**Response to Defense Nuclear Facilities Safety Board (DNFSB) Comments  
in DNFSB Letter dated November 4, 2002**

The following information identifies each of the DNFSB comments or issues and provides a U.S. Department of Energy (DOE) response, identifies actions taken to date, and actions that are currently planned to support construction activities.

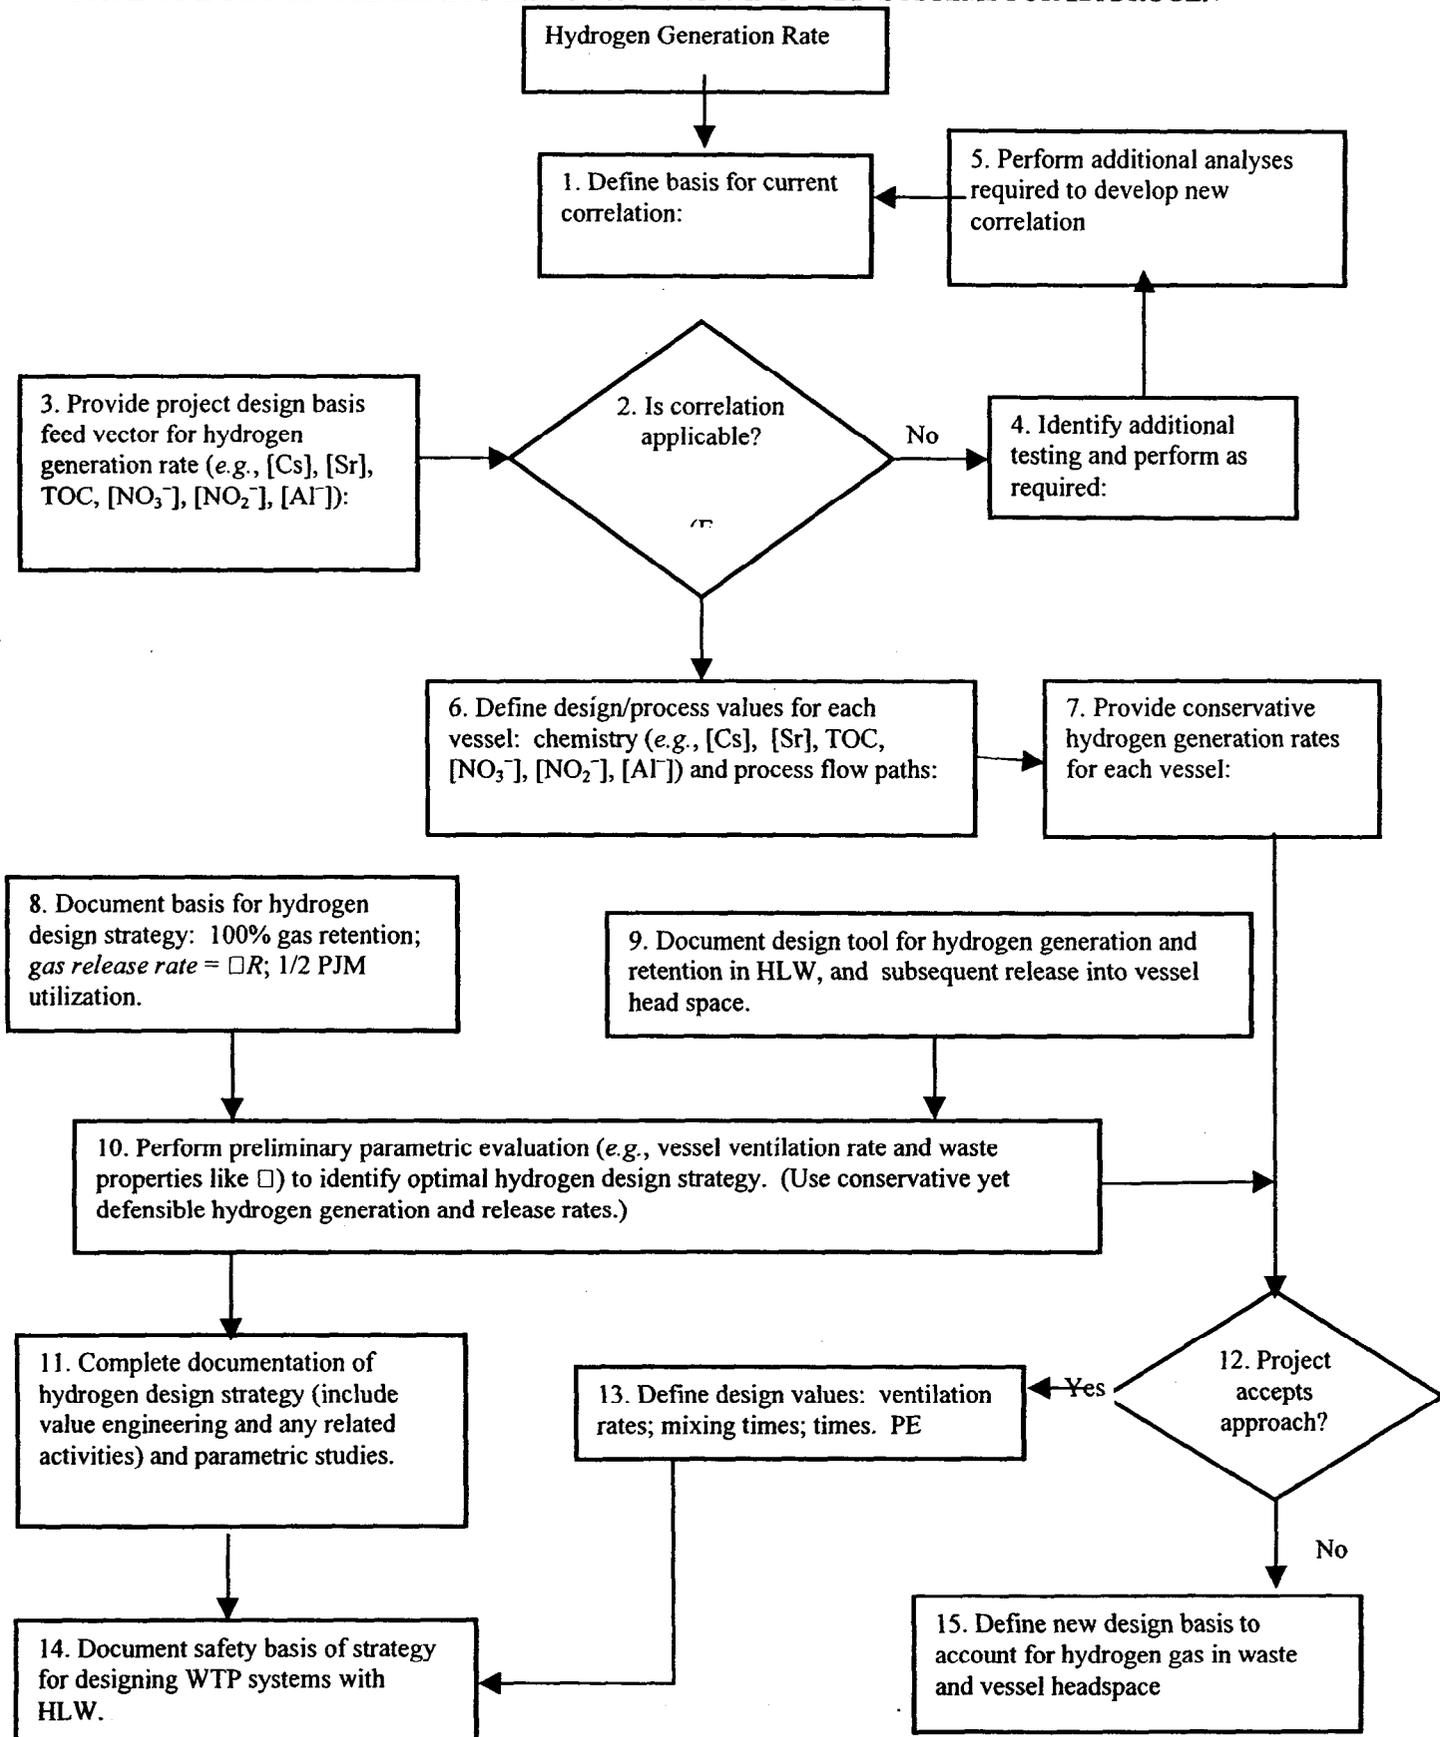
In at least one instance, the model underpredicted by approximately 25 percent the hydrogen generation within Tank AW-101 compared to that tank's measured generation rates. This discrepancy is significant as Tank AW-101 will provide feed during the initial WTP operating period (Phase 1). Moreover, this discrepancy demonstrates that the current model may not yield conservative or bounding hydrogen generation rates. A proper understanding of the driving mechanisms behind hydrogen generation and the sensitivity of various inputs is required, rather than an increase in the conservative estimates for some individual inputs. Additionally, as the PVP system is currently in design and nearing procurement, a sufficiently conservative predictive model for hydrogen generation rates needs to be developed in a timely manner.

BNI has chosen to model hydrogen generation rates using a model developed for the tank farms. This model was developed in the early 1990s to better understand flammable gas generation in Tank SY-101. This approach may not produce sufficiently conservative generation rate values since it does not address other important variables involved in hydrogen generation. In at least one instance, the model underpredicted by approximately 25 percent the hydrogen generation within Tank AW-101 compared to that tank's measured generation rates.

DOE agrees that using the 1997 hydrogen model developed for the tank farms and conservative input values to model hydrogen generation rates may not produce sufficiently conservative generation rate values.

In light of the issues raised by the DNFSB staff regarding the shortcomings of the correlation, (i.e., under prediction and no consideration of alpha), an effort was undertaken to demonstrate that by using conservative input parameters, including the effect of alpha emitters, a bounding defensible hydrogen generation rate could be developed. The plan to remove uncertainty in the understanding of hydrogen generation is shown graphically in the following Figure.

BNI has completed the activities identified in boxes 1 through 7 of the Figure, and concluded the correlation identified in RPT-W375-SA00002 is not a conservative methodology for predicting hydrogen generation rates ( See 24590-WTP-RPT-RT-02-006, *Predicting Hydrogen Generation Rates in Radioactive Waste Materials* for further discussion) (referred to as the R&T report). Using conservative input values for envelopes A and B the Topical Report correlation under predicted hydrogen generation in Tank AW-101; however, for envelope C, the correlation over predicted hydrogen generation in Tank AW-101.

The activities shown in blocks 8 and 9 of the previous Figure have been completed (24590-101-TSA-W000-0004-120-03 *Analytical Models Describing Global Hydrogen Retention and Release in WTP Mixing Vessels* [CCN: 048258]). This report characterizes and discusses the following:
